June 24, 2024

To: Plan Holders for Improvements to the
KIRKSVILLE REGIONAL AIRPORT
KIRKSVILLE, MISSOURI
MODOT PROJECT NO. 24-028A-1

**ADDENDUM NO. 5
TO
CONTRACT DOCUMENTS, SPECIFICATIONS AND PLANS
FOR IMPROVEMENTS TO THE
KIRKSVILLE REGIONAL AIRPORT
KIRKSVILLE, MISSOURI
MODOT PROJECT NO. 24-028A-1**

CE200

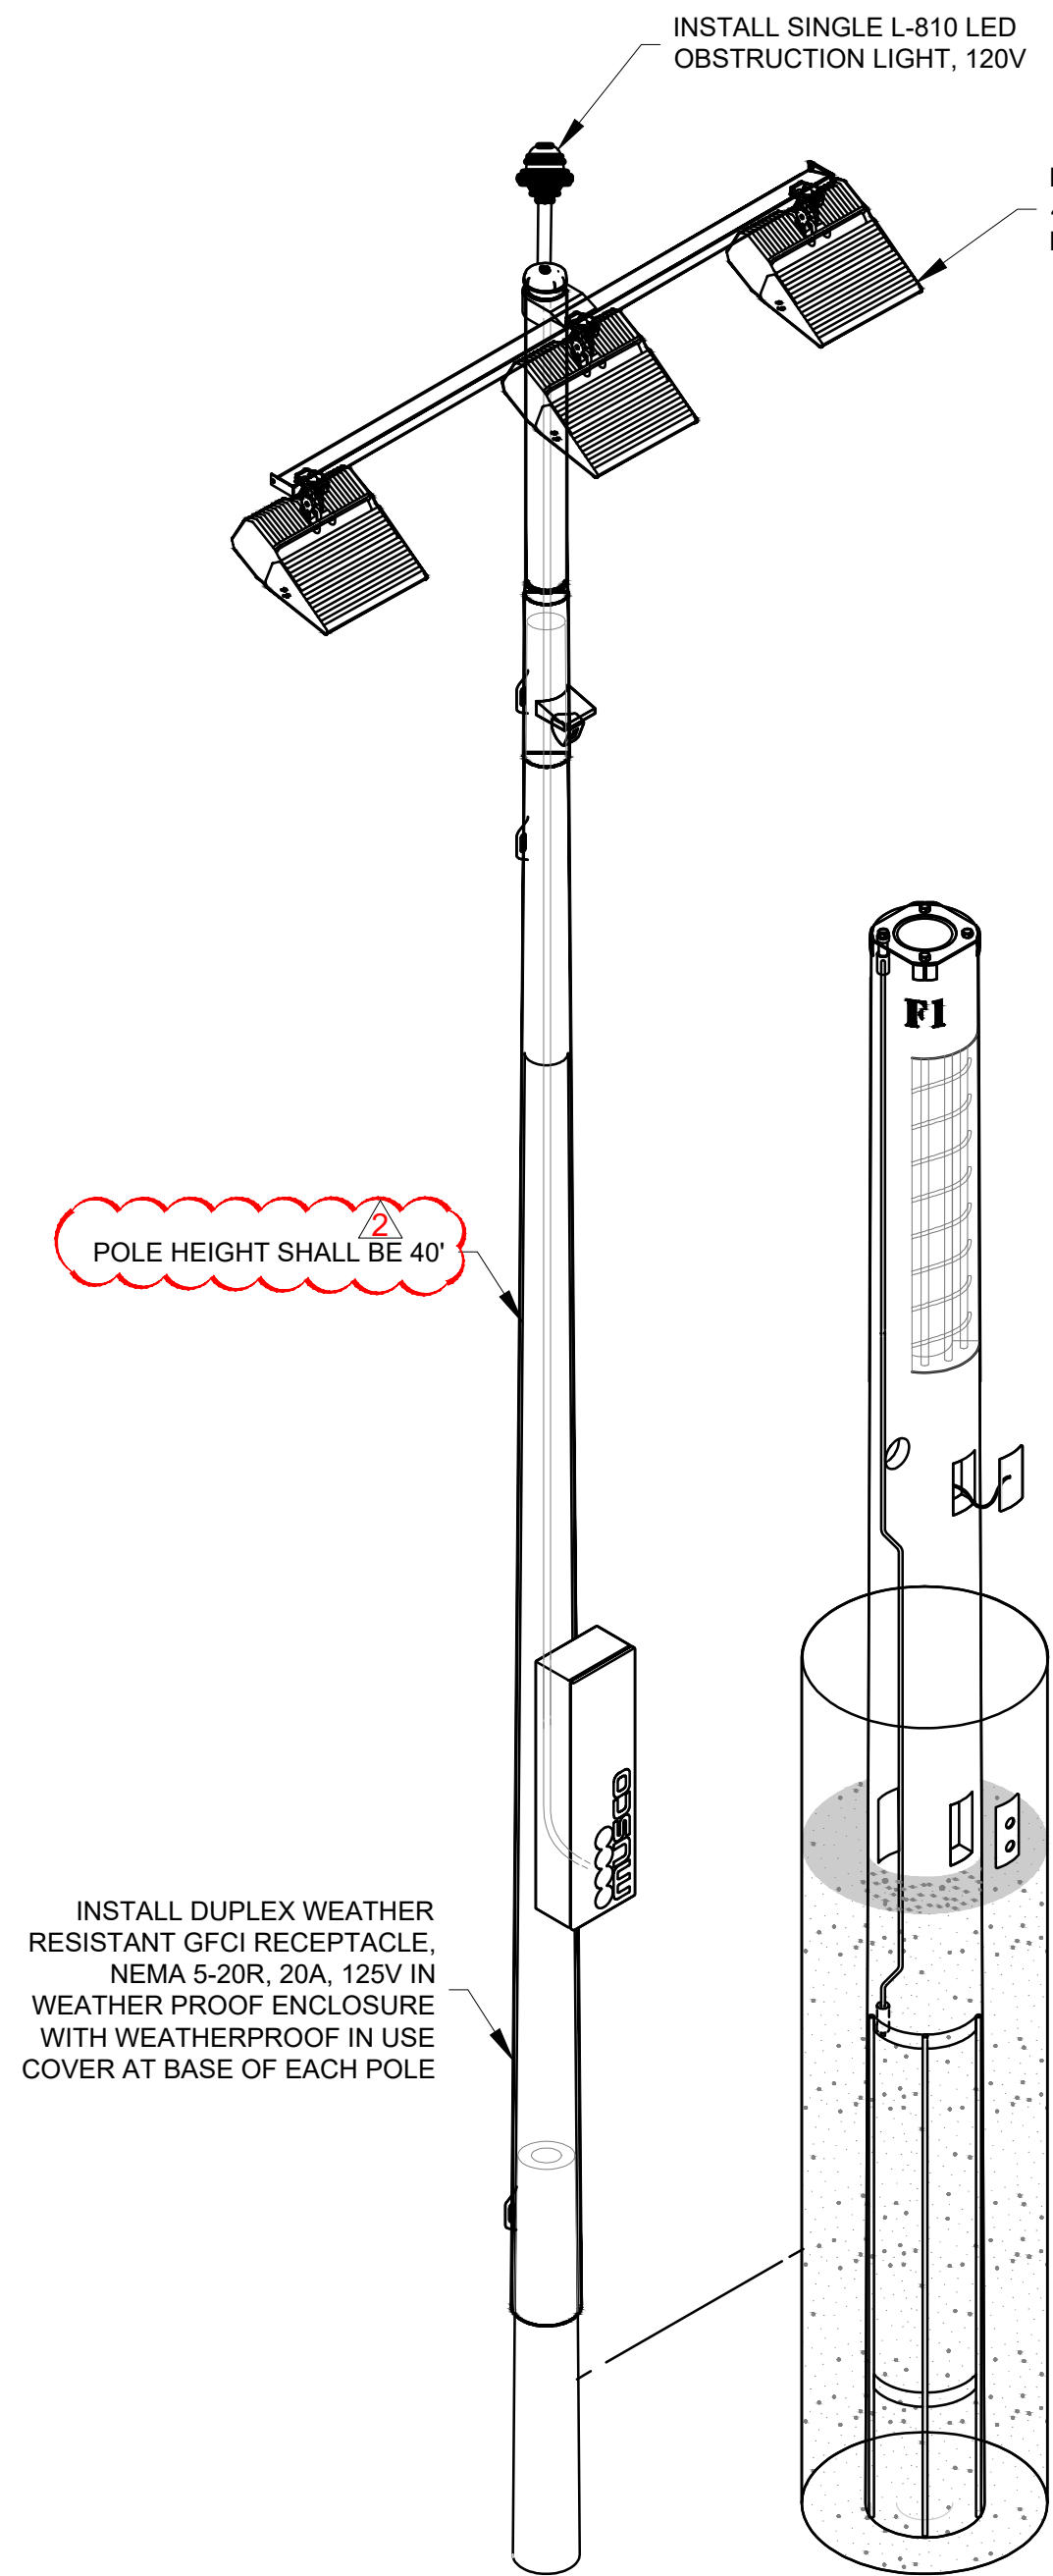
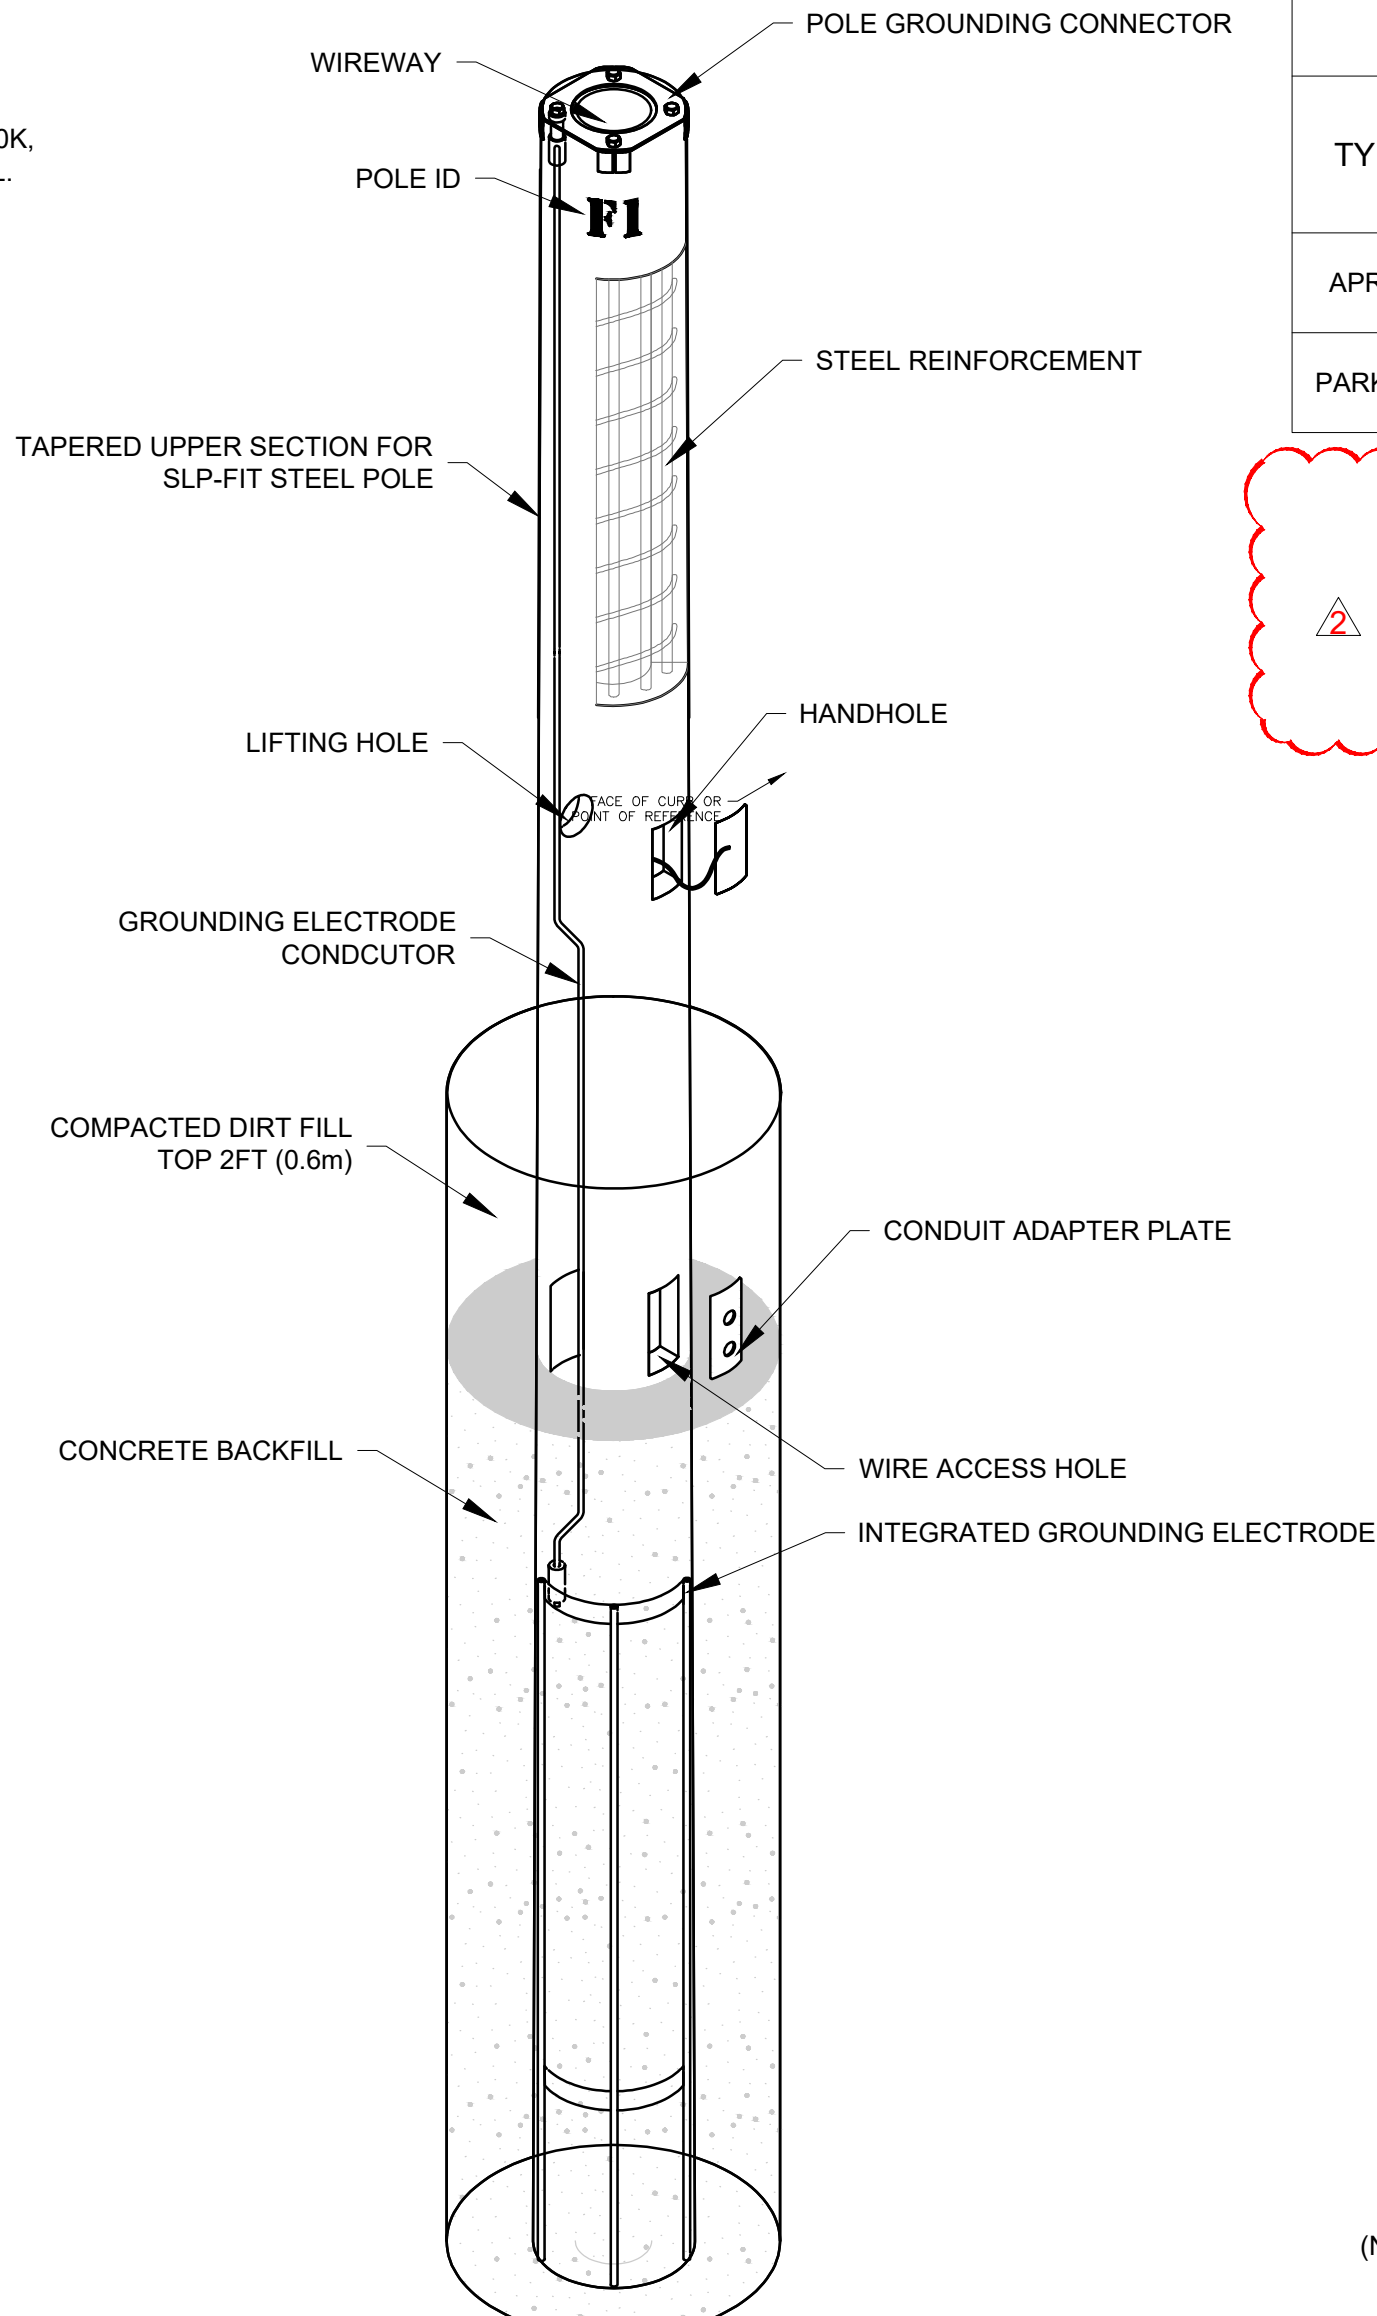
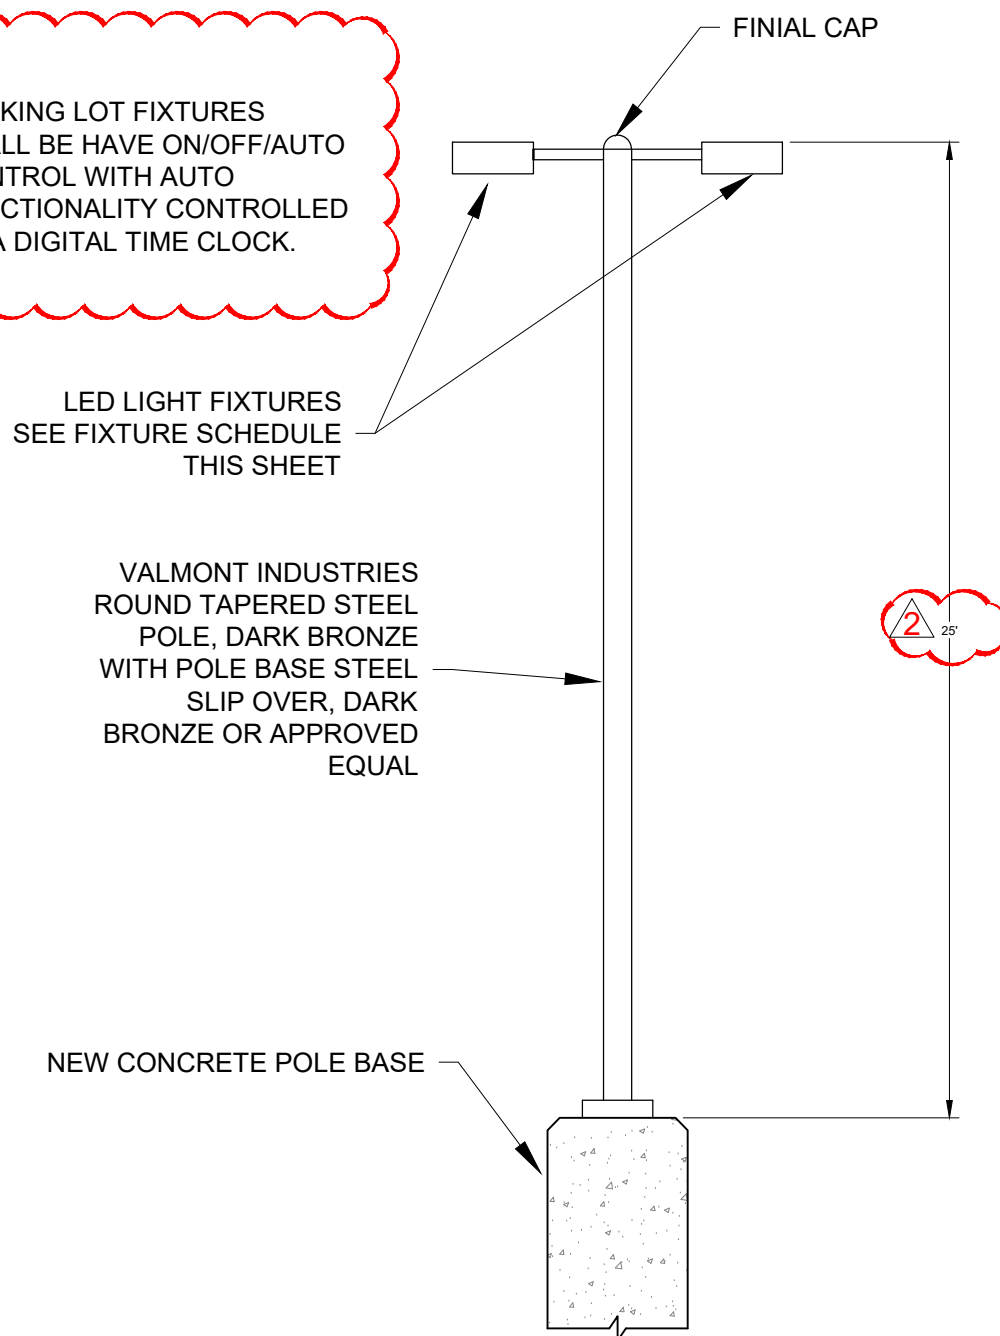
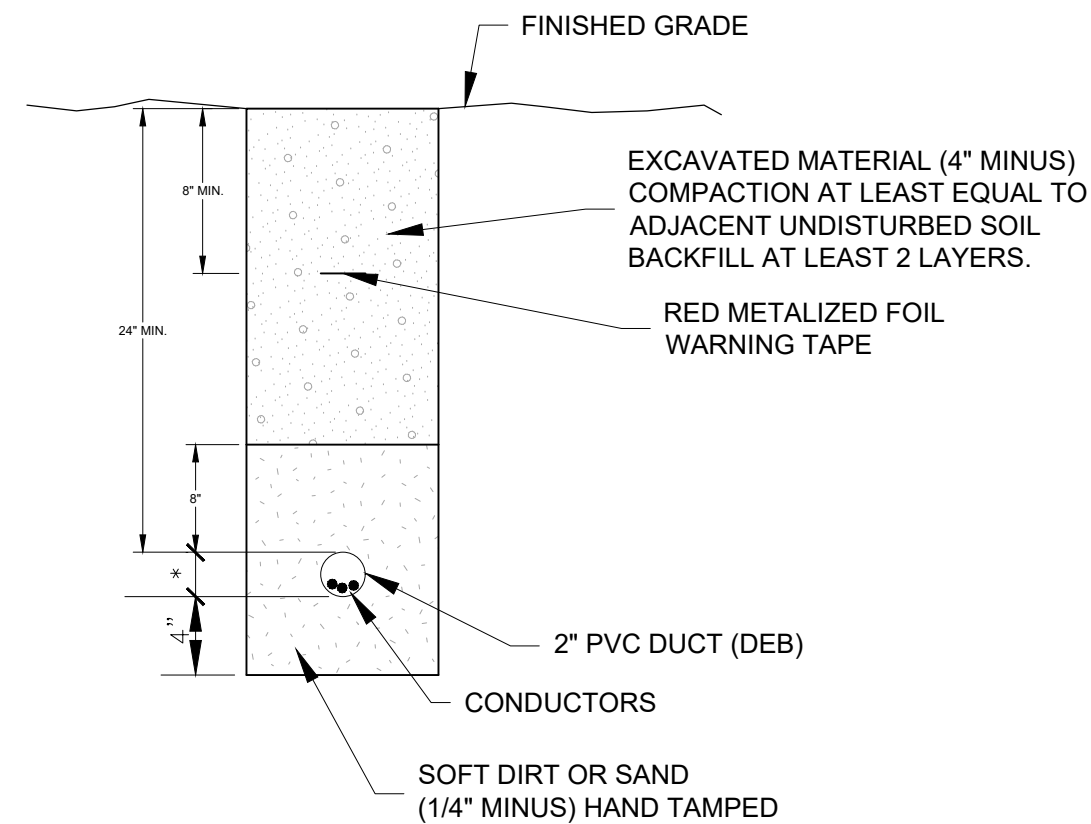
Sheet No.: CE200

Title: ELECTRICAL DETAILS

Revision: Updated fixture schedule and pole heights. Update the controls for the apron and parking lot lights to have a digital timeclock control.
